RFT 26-083 Interior Renovations & Air Conditioner Upgrades at Frontenac PS

The following, issued by the Halton District School Board (HDSB) June 18, 2026, shall be incorporated in the specifications and shall form part of the proposal document for the above.

TENDER ADDENDUM NO. 1
2026.06.17

Interior Renovations and Air Conditioner Upgrades at Frontenac Public School
Halton District School Board RFT 26-083
5140 Pinedale Avenue, Burlington, Ontario

Drawing No.:
A1.6

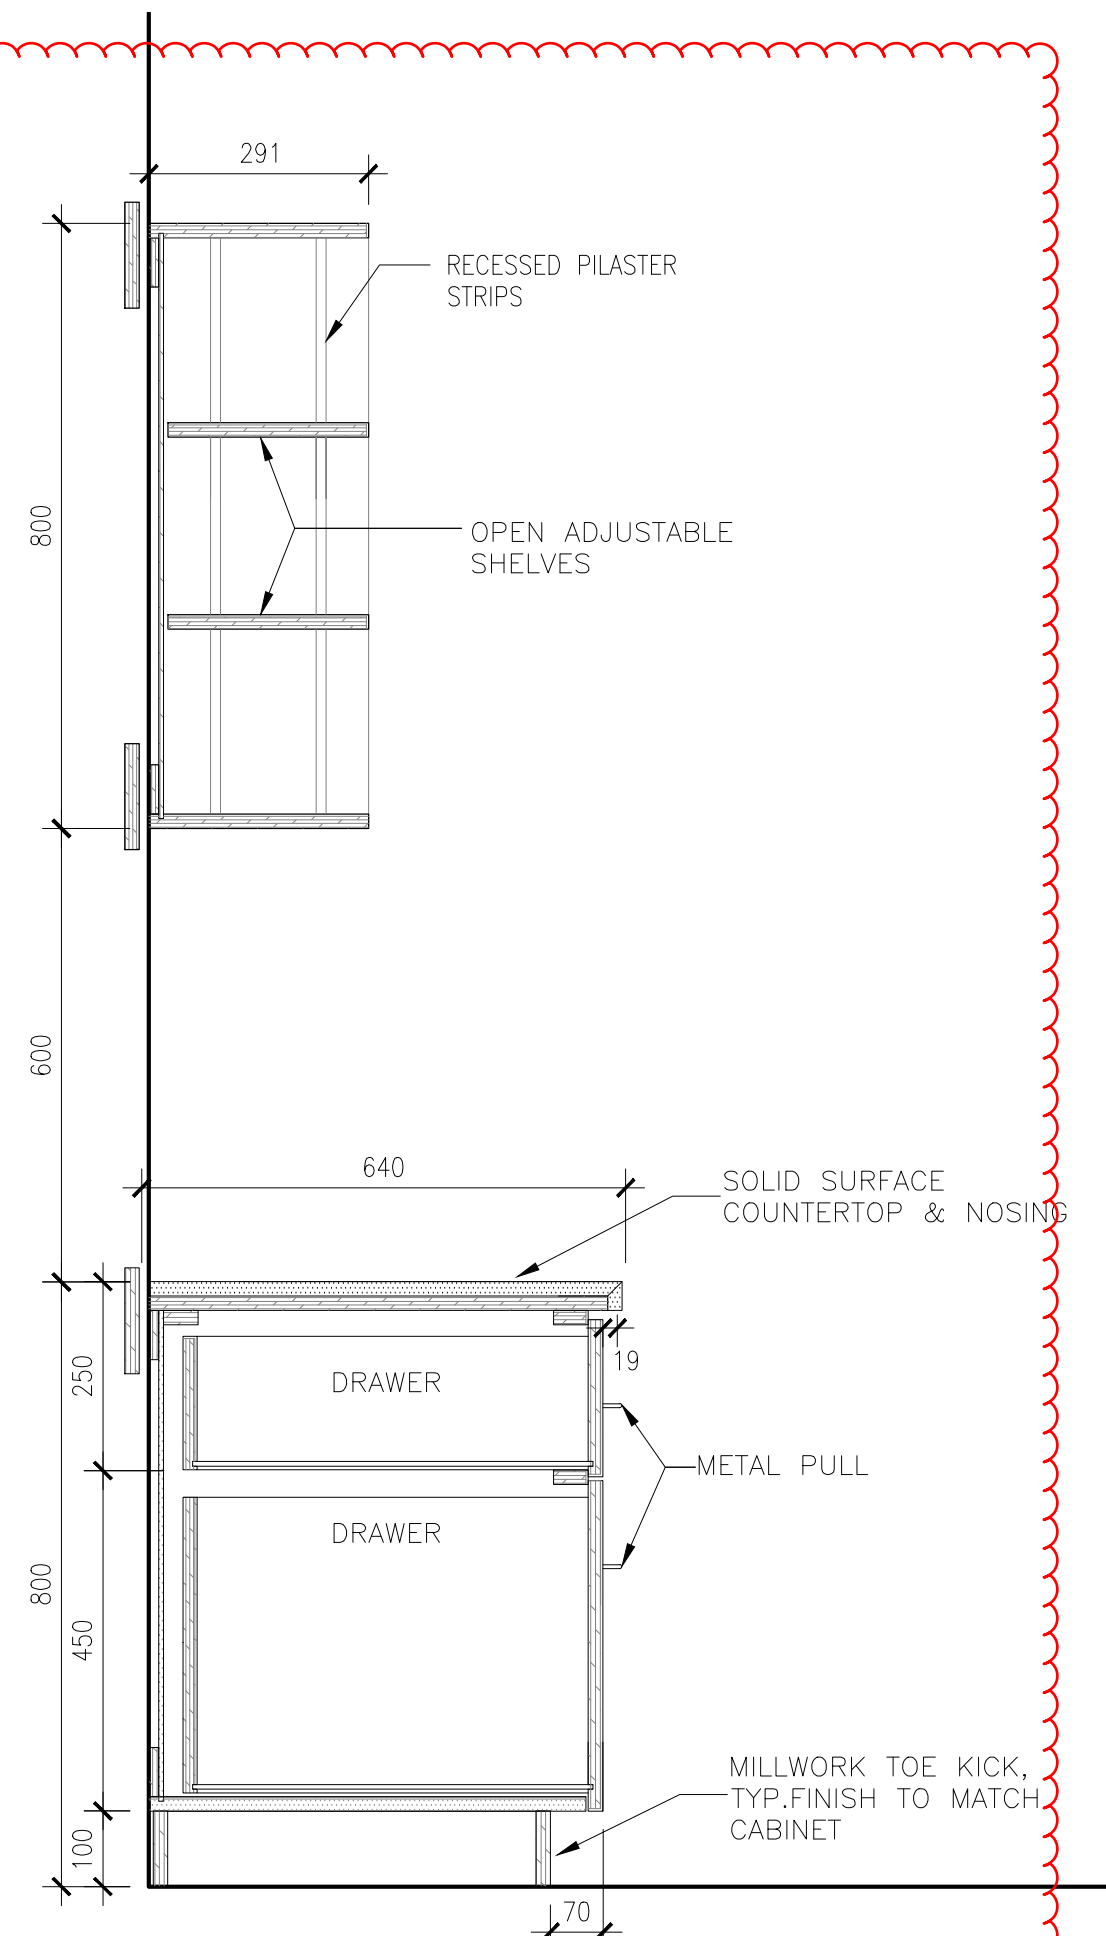
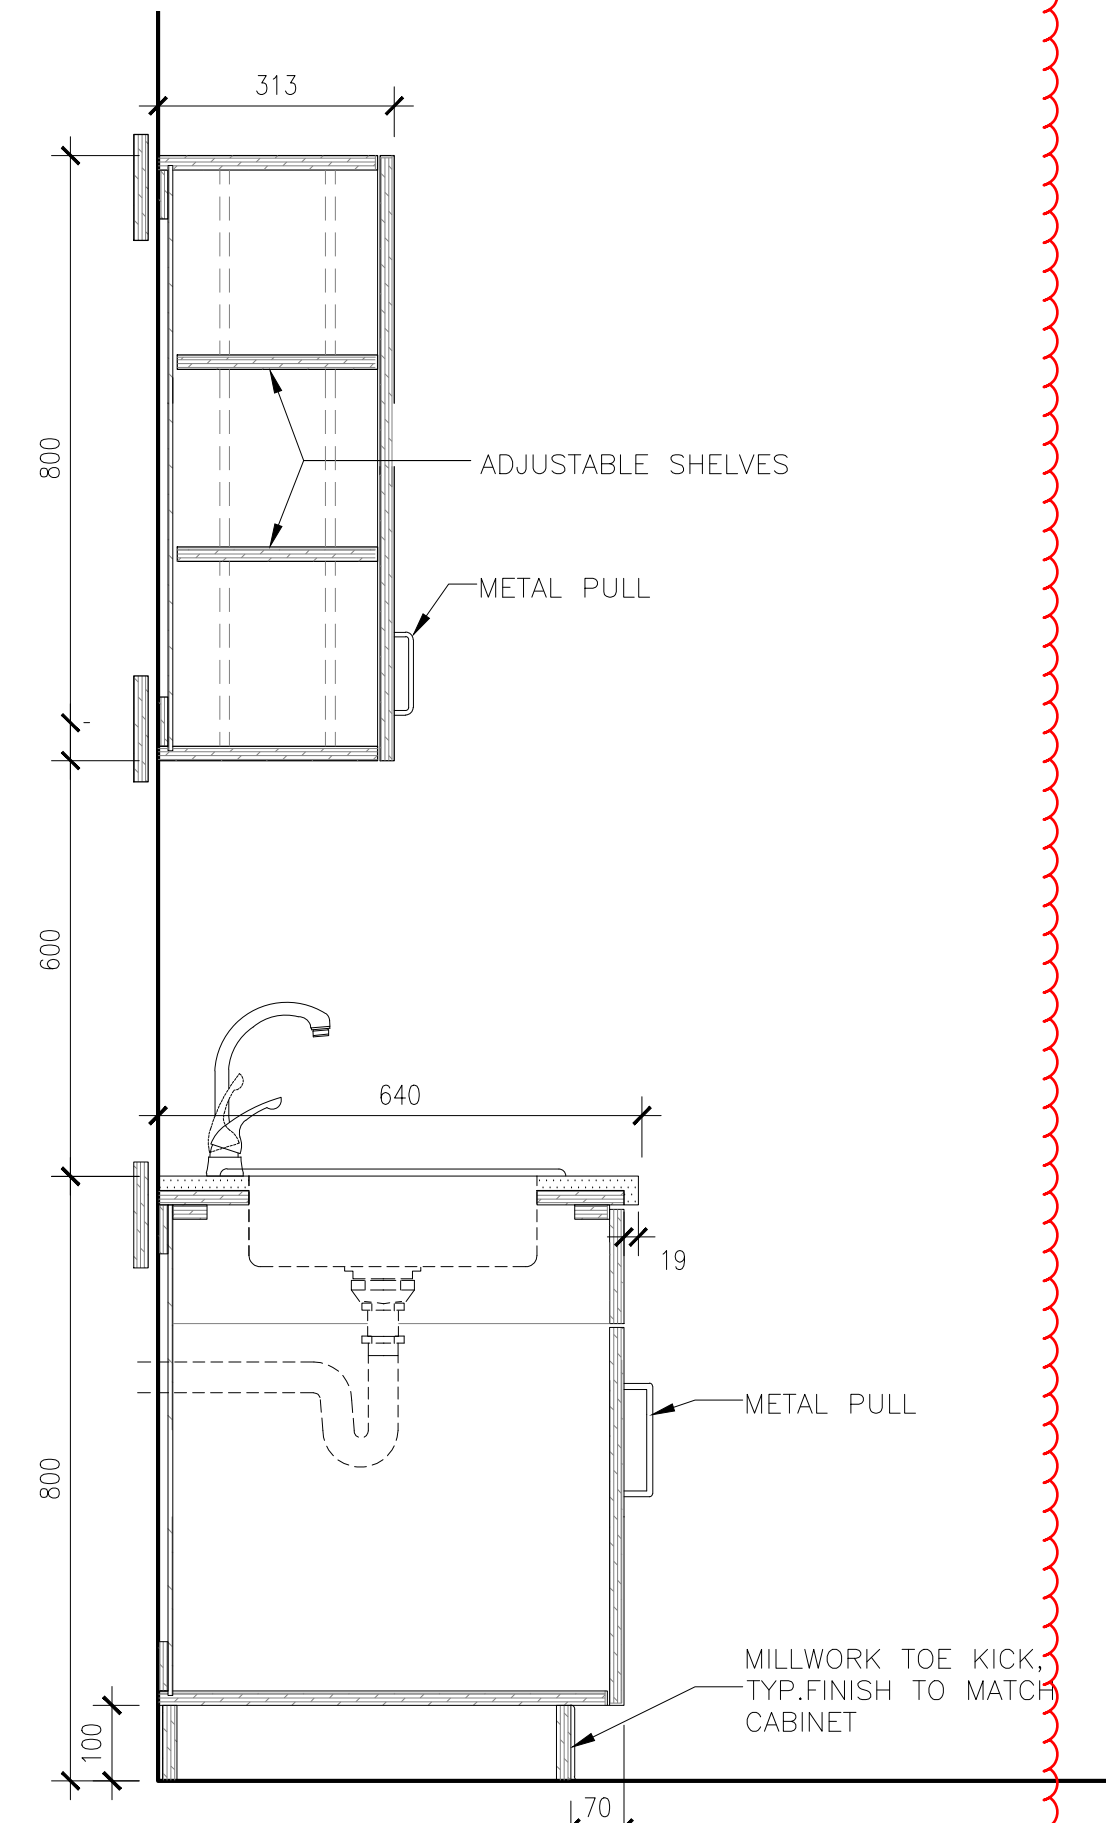
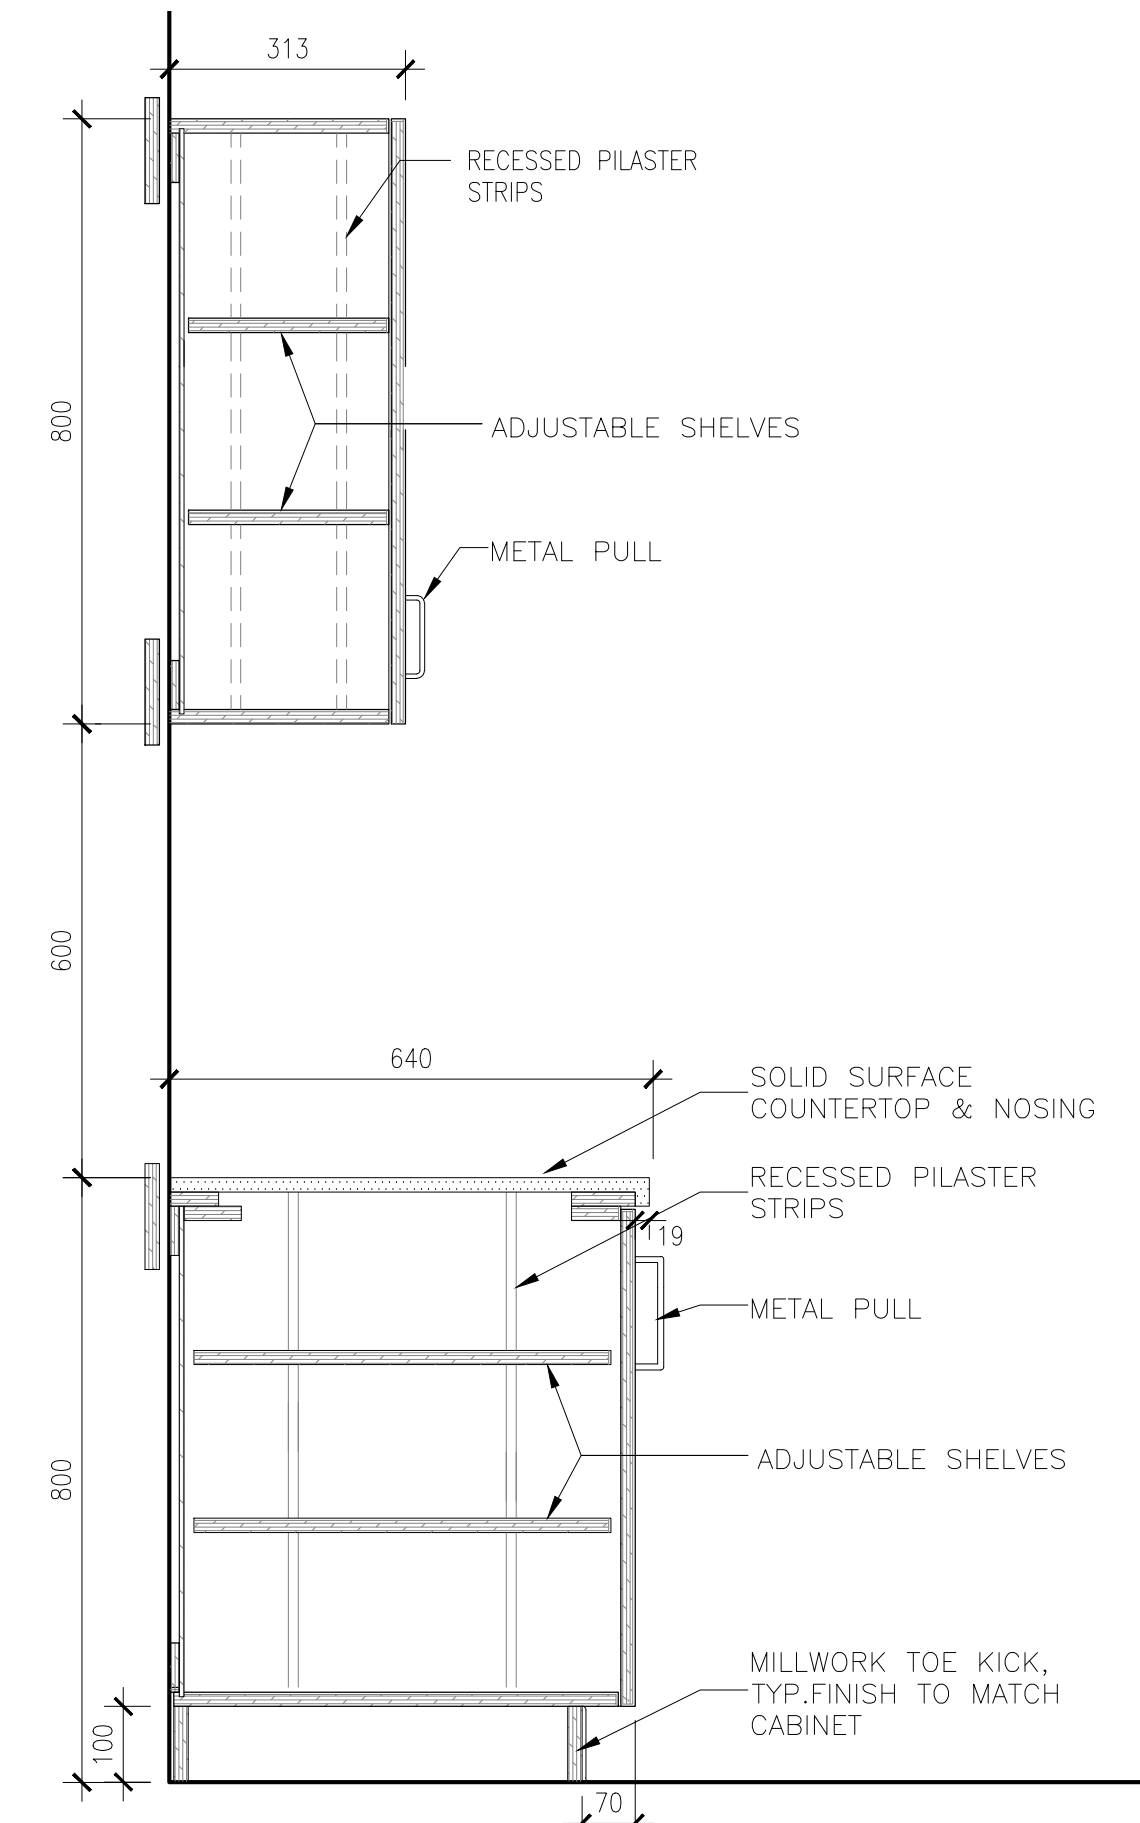
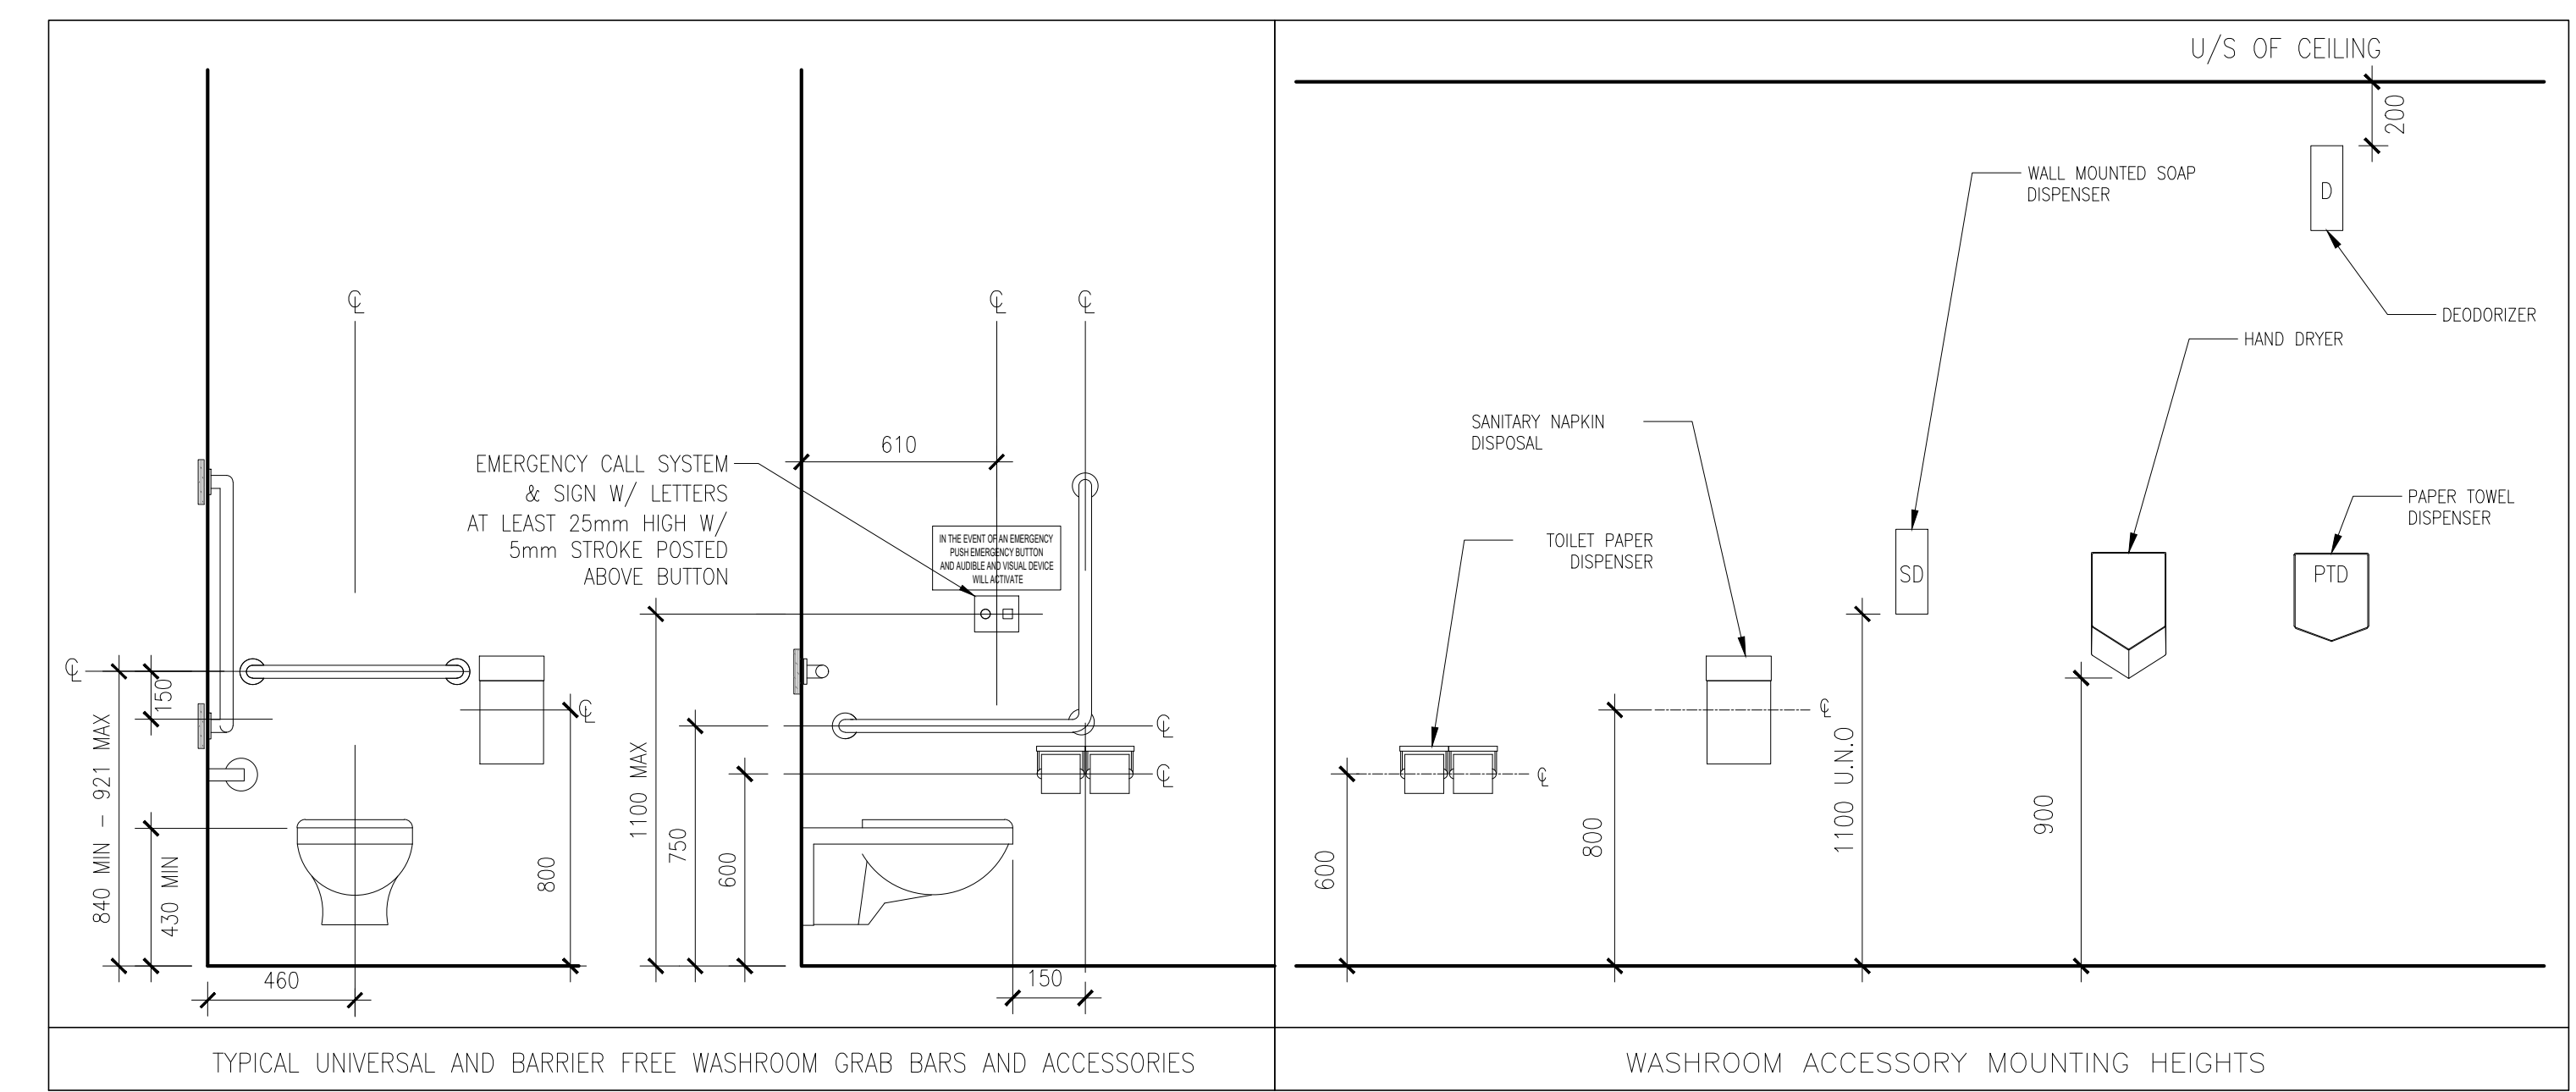
1.8: Drawing A1.6 Washroom Details & Millwork:

1. Drawing A1.6 RENAMED as Washroom Details & Millwork. See attached revised drawing A1.6 with bubbled revisions.
2. Details 5/A1.6, 6/A1.6 and 7/A1.6 relocated from Drawing A1.2. See attached revised drawing A1.6 with bubbled revisions.
3. ADD Millwork Section Details 10/A1.6, 11/A1.6 and 12/A1.6. See attached revised drawing A1.6 with bubbled revisions.
